**Monitoring Year 3 Report**  
**FINAL**  
**Meadow Brook Stream Restoration Project**  
**Yadkin County, North Carolina**  
**Yadkin River Basin, Hydrologic Unit Code (HUC) 03040101**

NCDEQ Contract No. 7184  
DMS ID No. 100024  
RFP No. 16-006993  
USACE Action ID No. SAW-2017-01509  
NCDWR ID: 2018-0919

**RE:                Response to the Draft Monitoring Year 3 Report for the Meadow Brook Site  
                      Yadkin River Basin – CU 03040101– Yadkin County  
                      DMS Project # 100024  
                      Contract # 007184**

XS4 looking upstream

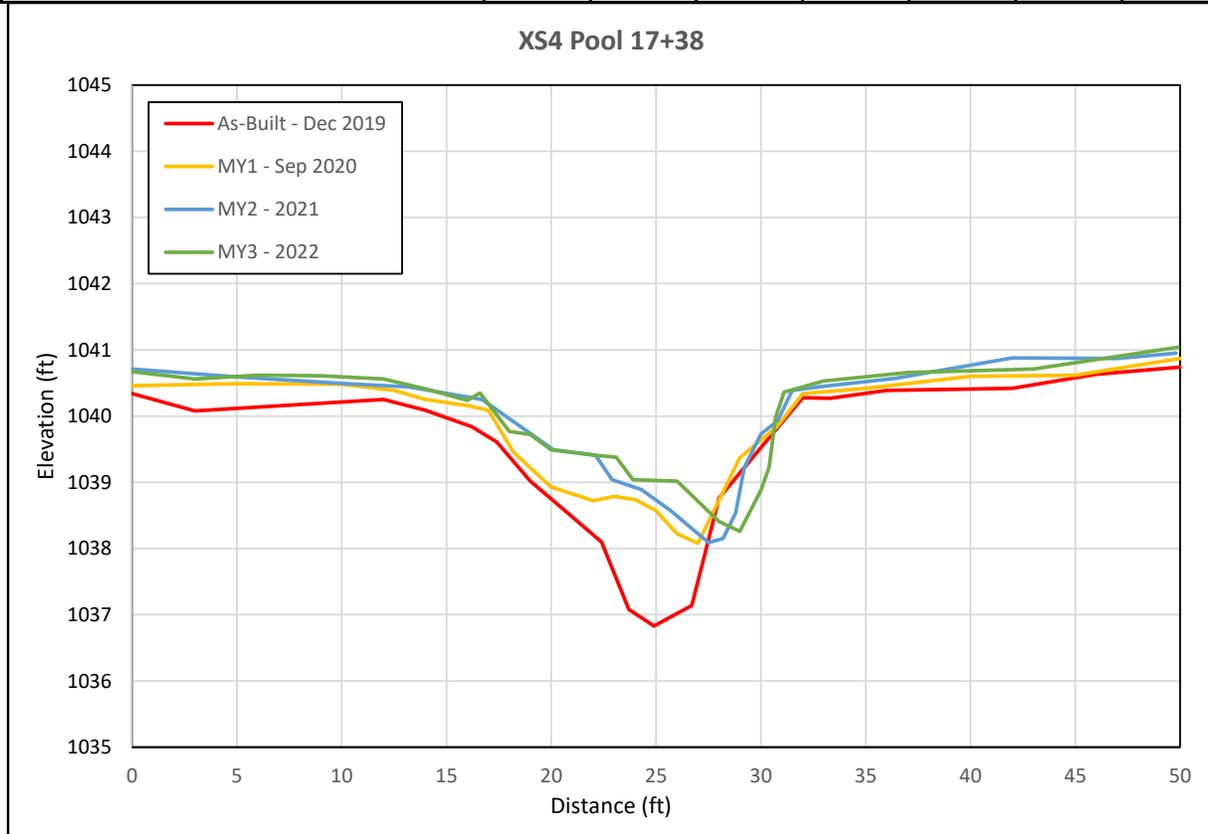
- *Pool cross sections 4 and 13 have shown some geomorphic changes since MY0, including some infilling; can EPR summarize these changes and how they might or might not be a concern moving forward?*
  - **This has been clarified in the report document. EPR believes this accrual of sediment is primarily due to channel vegetation, which should become less of an issue in future years as the channel becomes more and more shaded. Most of the infilling in these two pools occurred in the first year of**

**monitoring but the pools appear to have stabilized since then. EPR will monitor these cross-sections in future monitoring years to ensure that the channels continue to clear and remain stable.**
